Incompleteness Review – responses for Cedaroak Park Trash Compactor

DR-11-04 Class I Design Review for trash compactor at Cedaroak Park Primary School

1 REFERENCE PLAN - SITE
 SCALE: 1"=40'-0"

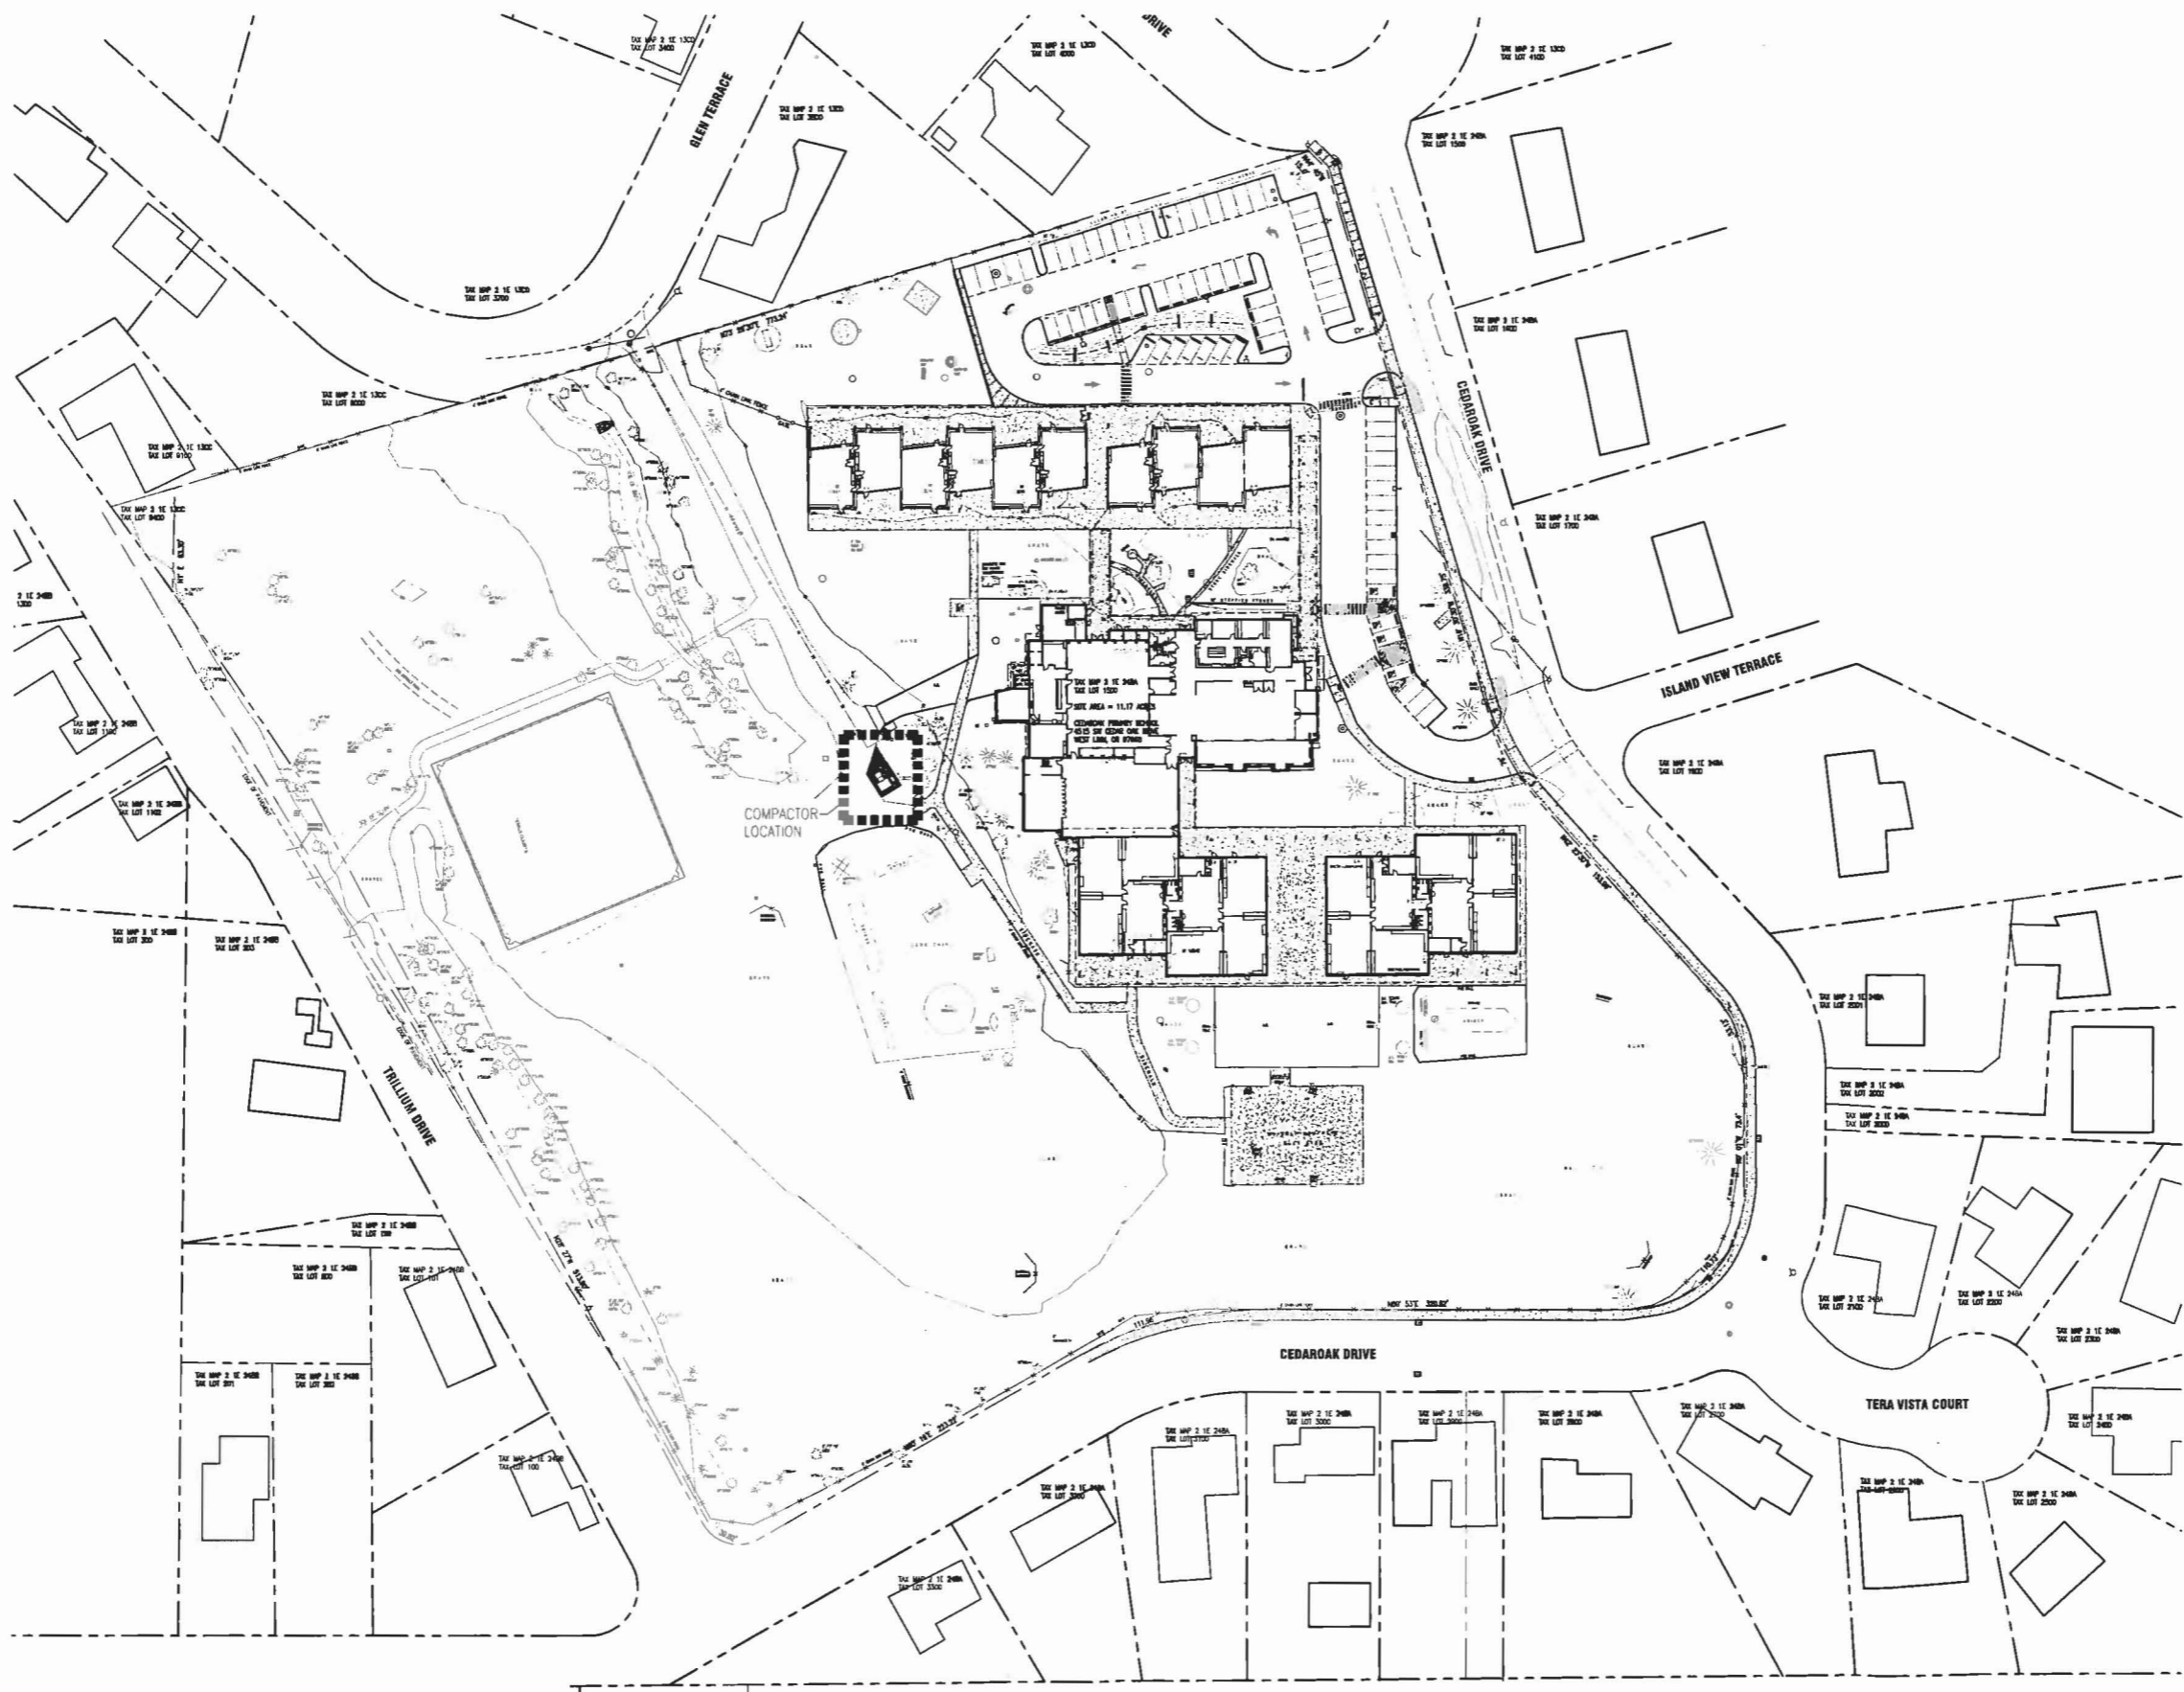
Show structure footprints on the nearby sites shown on site plan

Response: See attached site reference plan.
